# DHDC 22-8059

### CERTIFICATE OF APPROPRIATENESS

**RE: Application Number 22-8059; 506 Parkview St.; Berry Subdivision Historic District**

# Proposed Solid Wrought Iron Fence 506 Parkview DR, Detroit

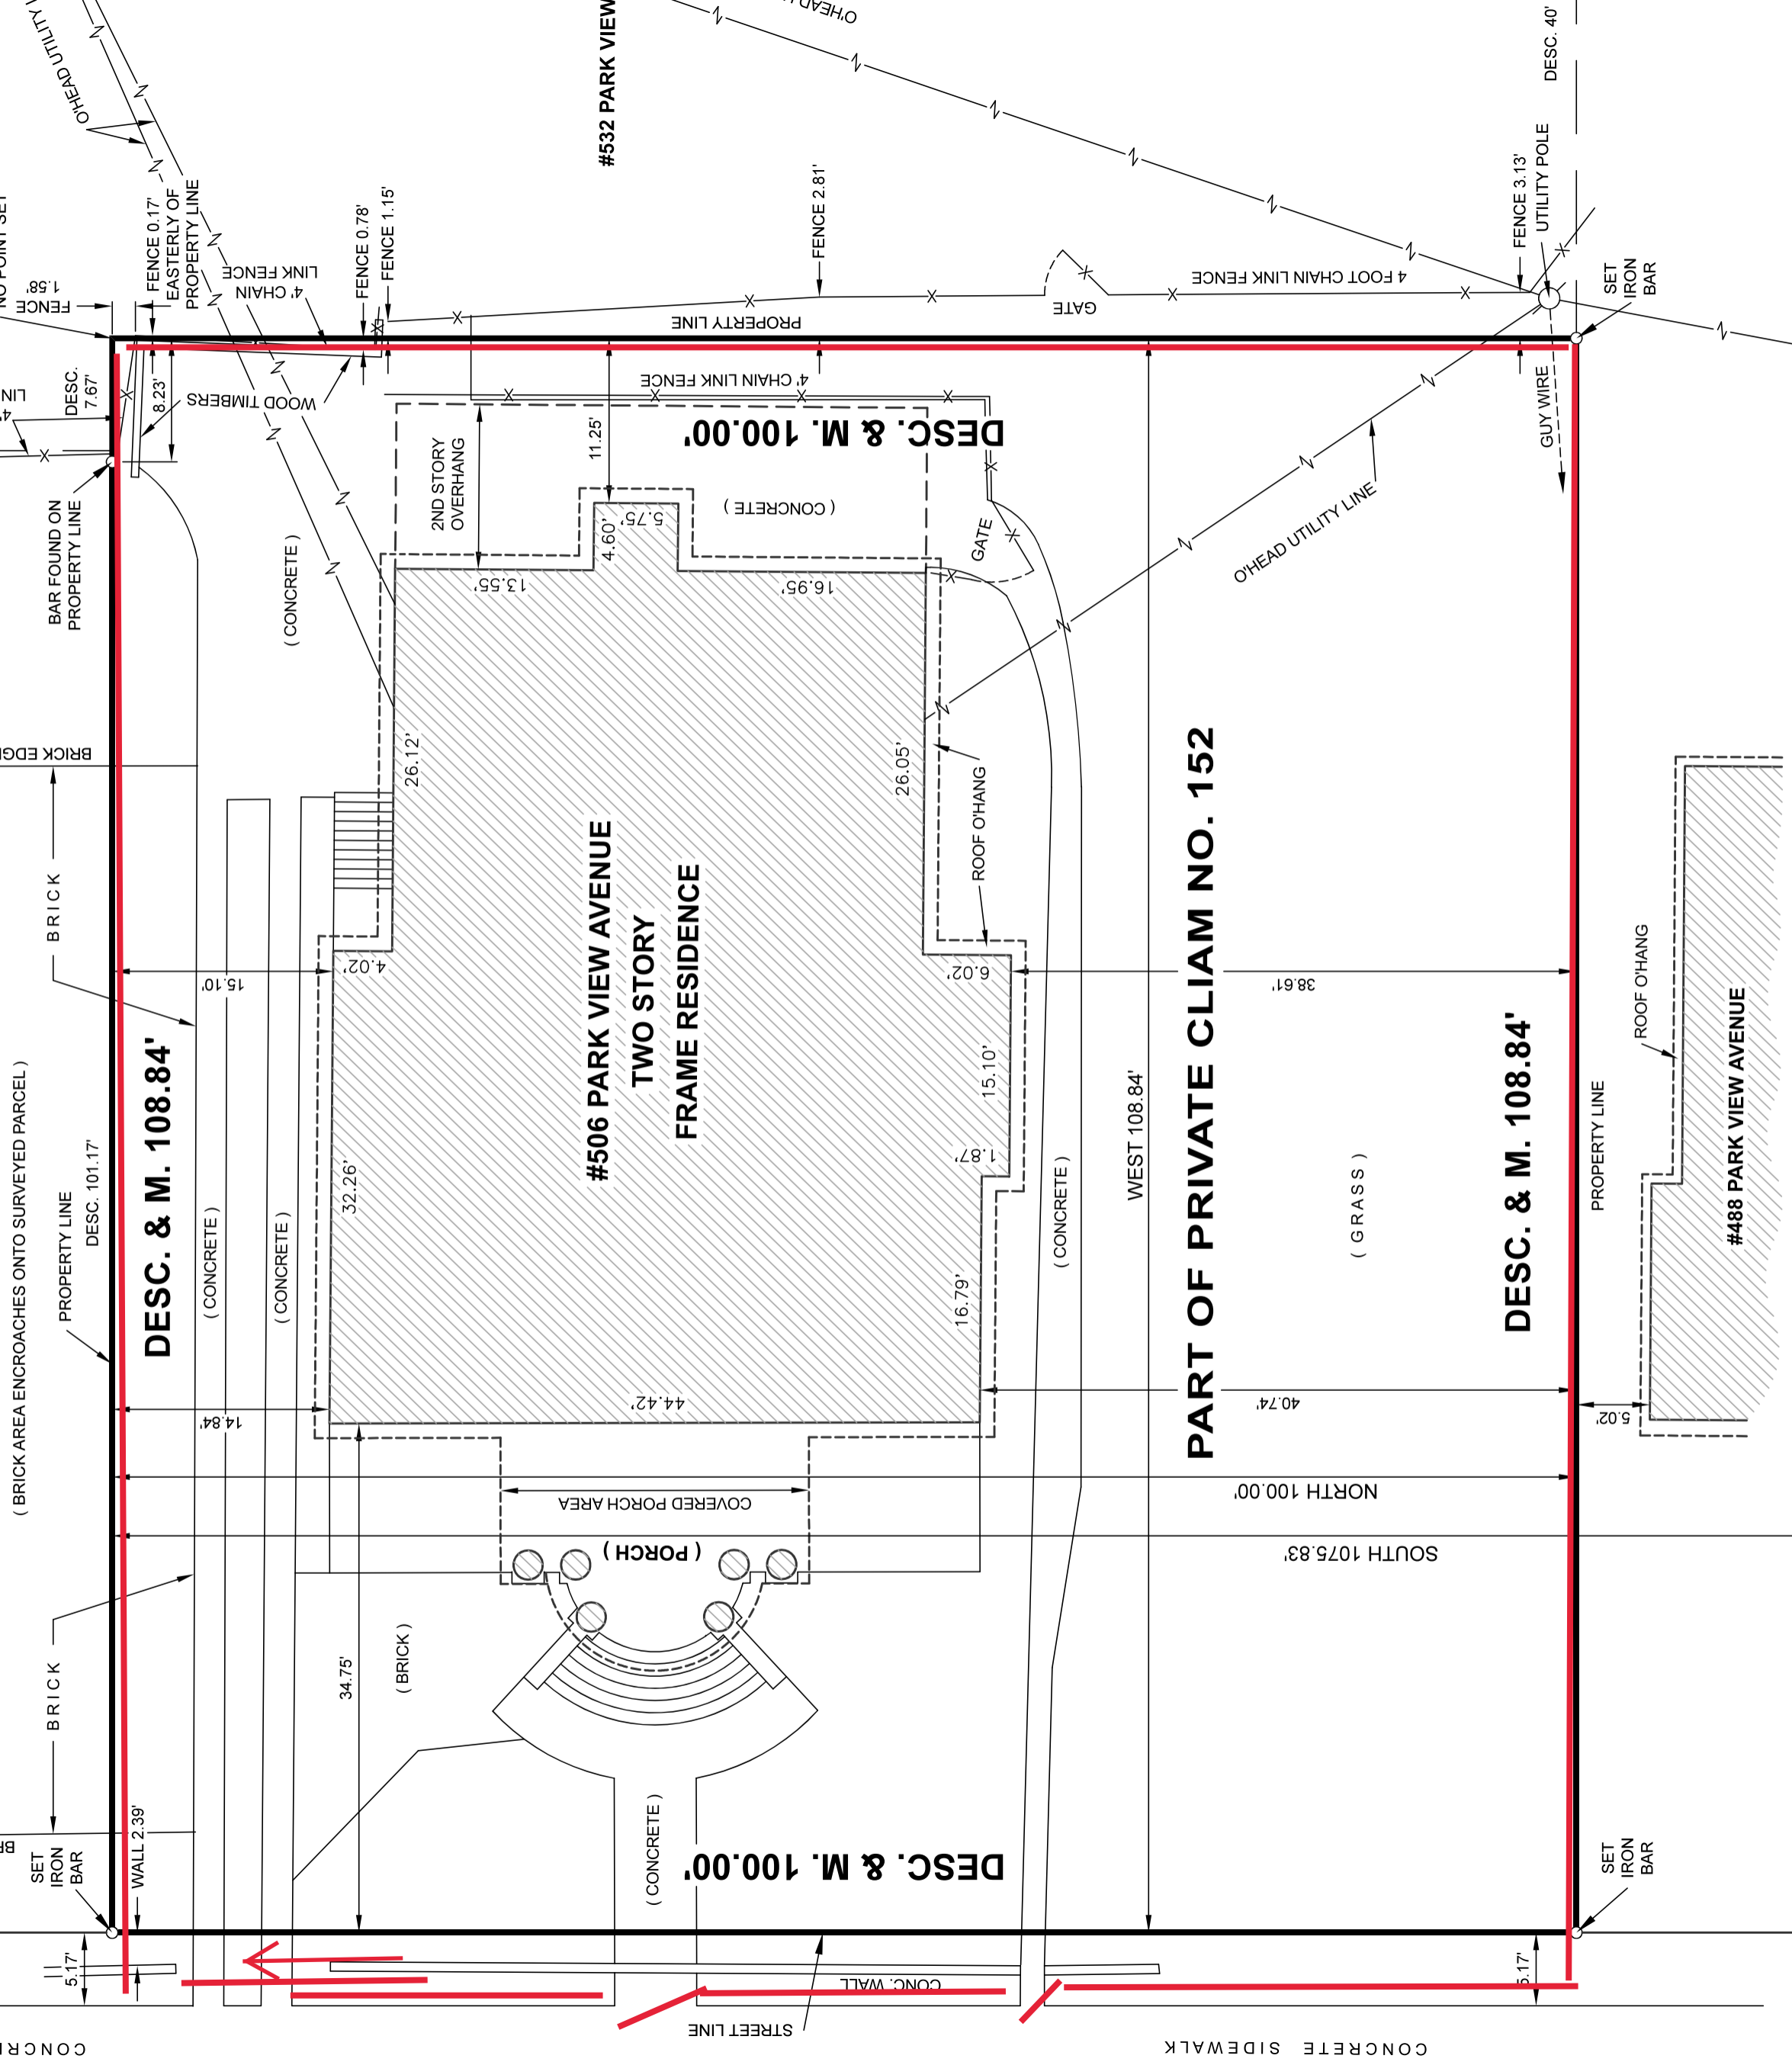
- ***The fence line be located at or inside the property line.***
- ***The fence and gates along Parkview measure no higher than 5 feet.***
- ***Staff receive final plan and drawings that show the fence location and height before installation.***

1. There is a parking lot to the north side of the house, which appears to be in the middle of the plan for the proposed fence. How will the fence run through this parking lot? Is this parking lot to remain as is? What would the conditions of this fence and parking lot look like?

- 1.
2. There is a grade beam (slight retaining wall) along the front face of the front yard along the property. Will this remain as is? If the proposed fence is 6 feet high, then the fence on top of this raised area could be as high as 7 feet at this location by the sidewalk. Do you propose to maintain the maximum height at 6 feet by the sidewalk, despite the changes of the grade? (So the maximum height would be 6' from the height of the sidewalk.)

- 2.
3. Generally, the HDC prefers that front yard fences do not extend beyond the front face of the house. Can you provide a reason as to why the fence needs to be extended the front yard to the property line?

That paved brick area was put in about 30 years ago when both houses were under the same ownership as bed and breakfast. Our property owns about 5 feet of that brick area and we would run the fence along the property line over the brick. The house next door has its own paved parking on the north side. They usually let the lawn grow and cover the bricks anyway. They have no access to park in that area unless they were to use our driveway.

We would like to put the fence in front of the grade beam at the lower level between the beam and the sidewalk. That would actually make the 6 ft fence lower in comparison to the lawn behind. That will also allow a sliding driveway gate and motor at ground level. We would allow the fence to slope up along the property on each side.

Two reasons. -security and because the rest of the properties to the south already have fences at this line. We are investing hundreds of thousands of dollars to bring back this historic home that was abandoned for ten years. During that time the original front doors were stolen as well as most of the plumbing and electrical. We have had the front doors recreated exactly like the original 10 foot high pair. The house tends to attract tourists and people wanting to explore. We would rather they take pictures from the sidewalk. We have also had unpermitted filming set up on the lawn area in the recent past.
